## #10-05-23-002: Front Brake Squeak Noise on Brake Apply (Replace Front Brake Pads) - (Mar 25, 2010)

**Subject:** Front Brake Squeak Noise on Brake Apply (Replace Front Brake Pads)

**Models:** 2010 Chevrolet Camaro SS  
Built Prior to VIN Breakpoint A9172924

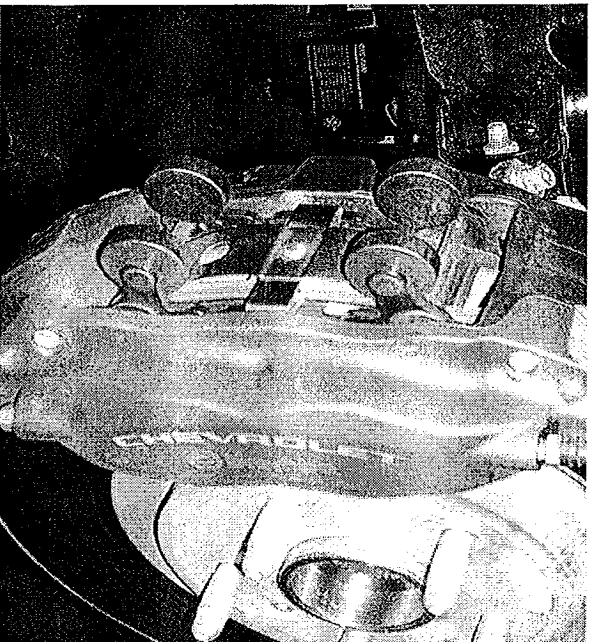
**Note:** New front brake pads have been released to correct this condition. When installing the new front brake pads, you must remove the factory-installed weights from the front brake calipers.

1. Replace the front brake pads with the replacement kit listed in the parts table below. Refer to Front Disc Brake Pads Replacement (L99, LS3) in SI.
2. Remove the factory-installed weights from the front brake calipers.

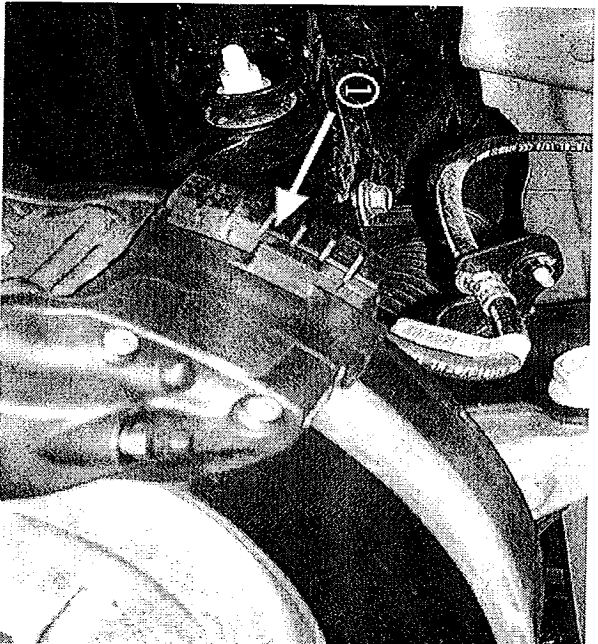
- 2.1. Apply penetrating oil (i.e. WD-40® or equivalent) to the weights (1) on both the right and left sides and allow the oil to set for a few minutes.

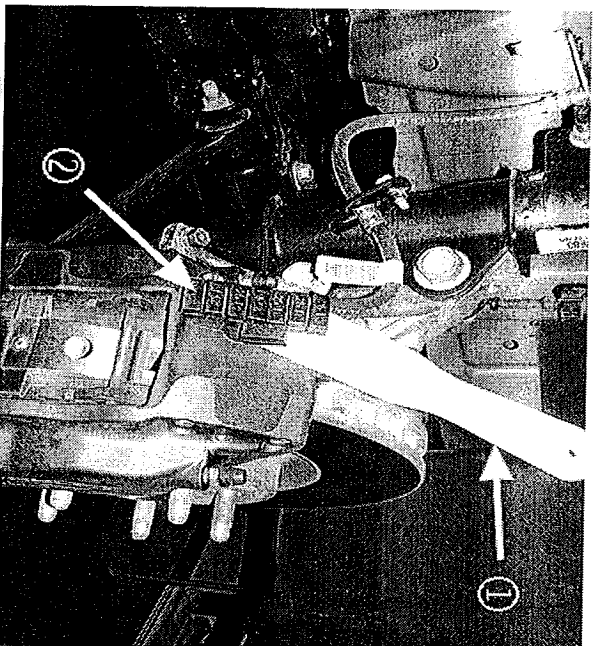
- 2.2. Use a plastic scraper (1) to remove the weights (2).
- 2.3. Clean any remaining adhesive residue from the calipers using Kent Automotive Acrysol™, P/N 20005, or 3M® General Purpose Adhesive Cleaner, P/N 08984, or the equivalent.
